**AGENDA FOR THE REGULAR MEETING OF THE
DESIGN REVIEW SUBCOMMITTEE**

Wednesday, September 10, 2014

Design Review Subcommittee (DRSC)

SUBJECT: Architectural Permit 14-329, Site Plan Permit 14-346, and Minor Conditional Use Permit 14-347, Estrella Shopping Center (Phase 1), a request to consider a façade enhancement for an existing shopping center. This is for the portion of the project site that was the K-Mart facility.

Table 1 – Proposed Elements, Staff Recommendation, and Basis for Recommendation

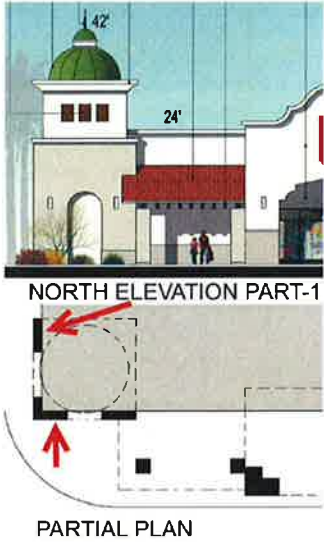
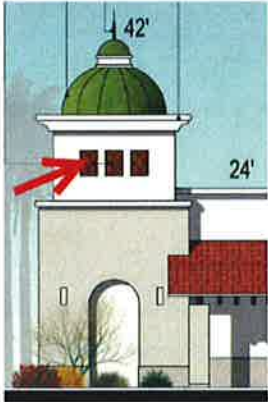
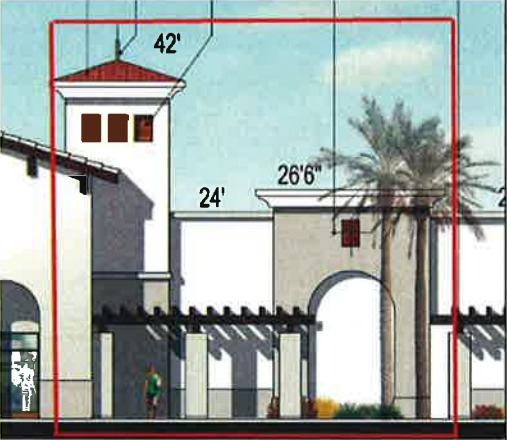
Proposed Element	Staff Recommendation	Basis for Recommendation
<p>Staff is supportive of the dome element of the tower, though some additional detail and scaling needs to occur.</p> 	<p>These are examples from the similar Ralphs tower that staff feels will enhance the design.</p> 	<ol style="list-style-type: none"> 1. The proportions of the tower seem off. The lower horizontal plane break should be higher above the 24 foot primary roof line. 2. Adding the simple decorative features at the corners of the lower break will fill in those areas appropriately. 3. The cornice under the dome should be reduced and simplified. 4. The arch at the bottom should be widened and increased in height and utilization of a similar stone cap around the arch would be beneficial to the design.

Proposed Element	Staff Recommendation	Basis for Recommendation
<p>Dimensionality of the elements are a concern to staff because the elements in the field will appear flat and not authentic.</p>  <p>NORTH ELEVATION PART-1</p> <p>PARTIAL PLAN</p>	<p>The areas noted with the arrows should be wider to appear as if they are supporting the elements above them. This will provide appropriate proportionality and shadow lines.</p>	<p>While these are façade enhancements, and the tower is not functional, more depth should be given to the elements so they are authentic in design and appearance.</p>
<p>The applicant is proposing tiles in these insets, and a simpler more authentic approach can be utilized.</p> 	<p>This simple design will provide a more authentic appearance.</p> 	<p>Utilized on several projects, this "chevron" design is a simple and elegant treatment to break up the use of tiles.</p>

Proposed Element	Staff Recommendation	Basis for Recommendation
 <p>H ELEVATION PART-1</p> <p>The collonade areas indicated by the arrows should be redesigned to resemble a more traditional arcade.</p>	 <p>This example from the Ole Hanson Beach Club is a good example of the arcade element.</p>	<p>This would help meet the Design Guideline requirements regarding pedestrian scale and be a traditional Spanish design.</p>
<p>The parapet wall embraces the Mission style, but the two end pieces should be better defined columns to bookend the entry. A decorative feature should be included at the top of the newly defined columns.</p>  <p>I PART 1</p>	<p>A smaller scale example from the Santa Barbara Train Station to complete the entry detail.</p> 	<p>Again this provides the correct massing and proportionality of the entry into Sports Authority.</p>
<p>The corners of the segmented arch should be traditional.</p>  <p>I PART 1</p>	<p>Here is an example of a corner detail from the City Golf Clubhouse.</p> 	<p>This detail proposed is more traditional. Staff recommends, if the applicant is not able to get the feature completed, a condition of approval be added requiring City Planner, or designee, to review and approve this design element.</p>

Proposed Element	Staff Recommendation	Basis for Recommendation
<p>There are several recommendations for the boxed area to simplify the design.</p> 	<p>The first recommendation would be to remove the darker plant on façade and simply do a column detail break that has more dimensionality and allow for the transition to the higher roof element. Here is an example of such an element with a traditional top feature from Plaza San Clemente:</p>  <p>Additionally, staff recommends removing the trellis elements, unless they will be used for landscaping, and do two things; 1) provide a simple stucco design similar to this to provide relief (scale, location on the façade, and proportions should be modified for the building):</p>  <p>2) To help the transition, and simplify the design between tenants, staff recommends using large pots or in ground plantings, irrigation, and trees to fill the space:</p>	<p>This will reduce and simplify the design, while making it more traditional and elegant. It will also enhance the pedestrian experience and scale which is required per the Design Guidelines.</p>

<p>The same landscape approach and details should be utilized on the other side of the Steinmart up to the transition to the Sprouts.</p>	
Proposed Element	Staff Recommendation	Basis for Recommendation
<p>Similar to the recommendations made above on the other side of the Steinmart entry, similar features should be incorporated. To simplify the design, staff recommends removing the tower.</p> 	<p>Removing the tower, and bringing in the design features discussed for the other side of the Steinmart entry will simplify the design, save costs, and make the scale and propositions more traditional and enhance the pedestrian experience.</p>	<p>The modifications will be consistent with the Design Guidelines and simplify the architecture.</p>

Proposed Element	Staff Recommendation	Basis for Recommendation
<p>With the goal to simplify the design and to be more traditional, staff has four (4) comments on this elevation.</p> 	<p>1) Consideration should be given to utilizing a different parapet wall cap. To introduce some additional red tile, staff recommends a tile parapet cap design similar to this:</p>  <p>2) Staff again recommends removing the trellis unless used for vines, and utilize the same approach of landscaping as discussed above, or perhaps utilizing stucco insets and allow for landscaping similar to what is shown on the side of the building.</p> <p>3) A traditional cloth awning (perhaps in green to match the Sprouts color palette) and wrought iron components to help break up this space.</p>  <p>4) As noted for the Sports Authority entry the opening should be a true segmented arch with corner detail.</p>	<p>These recommendations will simplify the design, introduce additional landscaping and additional red tile, awnings, and have true proportions, bringing the project into consistency with the Design Guidelines.</p>

Proposed Element	Staff Recommendation	Basis for Recommendation
<p>As recommended with the other tower, there are a few minor modifications that will enhance the design and make the tower more traditional and consistent with the Design Guidelines.</p> 	<p>As recommended above the arch should be widened and increased in height with a stone cap application which will provide some additional detail.</p> <p>The tower foundations, as recommended above, need to be increased in mass so it does not appear to be just a flat façade.</p> <p>The arches should have a minimum of a 12 inch inset and do not need the tile component. A simple approach to the arches as shown here would be appropriate:</p>  <p>The roof should utilize a 5/12 roof pitch to have accurate proportionality for an accent tower. This will increase the height, but be more authentic in design, scale, and massing.</p>	<p>These details will make the tower more traditional and authentic, and bring it into conformance with the Design Guidelines for accent elements such as towers.</p>

PROPOSED WEST ELEVATION SCALE: 1/4" = 1'-0" **3**

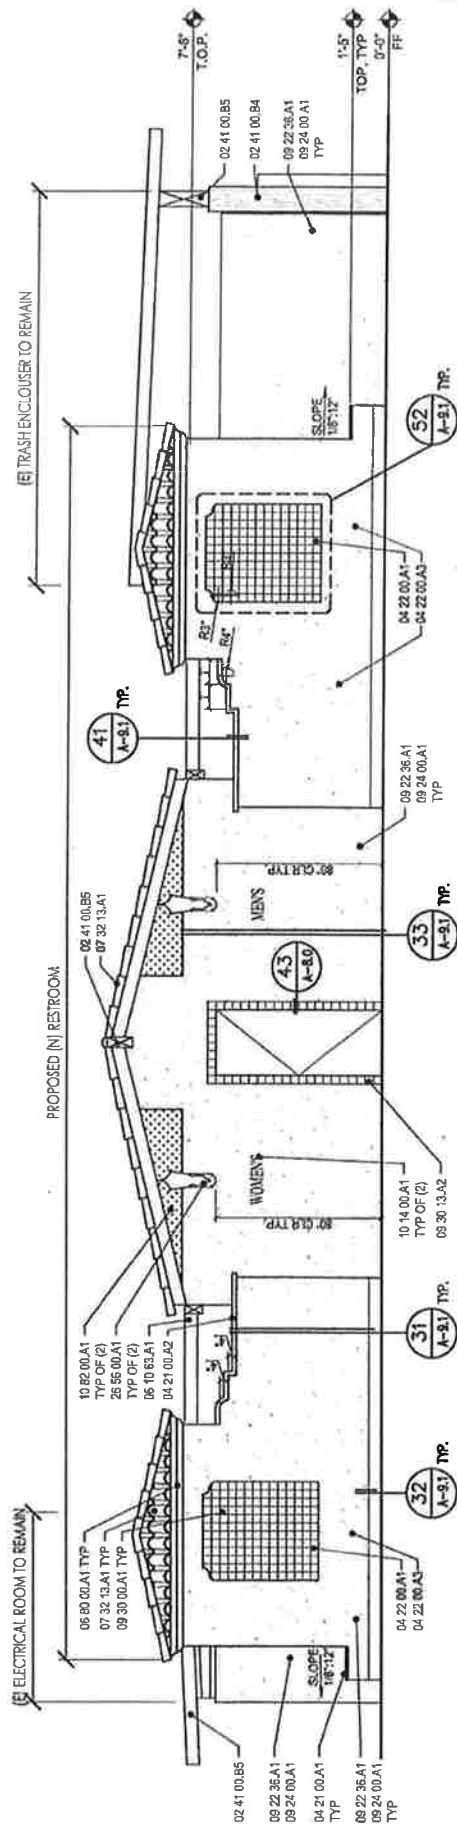
On October 16, 2013, the Planning Commission approved the Base of Pier Restroom project. The project is located at the south side of the base of the historic municipal pier within the Pier Bowl Specific Plan within the Beach and Parks – Open Space land use designation at 615 Avenida Victoria. In review of the project, it was understood that the two tile niche image options would return to the DRSC for input. City staff has narrowed the tile mural design options to ten images, provided as Attachment 1, and seeks DRSC feedback on the two preferred images. The front elevation depicting the location of the tile mural niches is provided as Attachment 2.
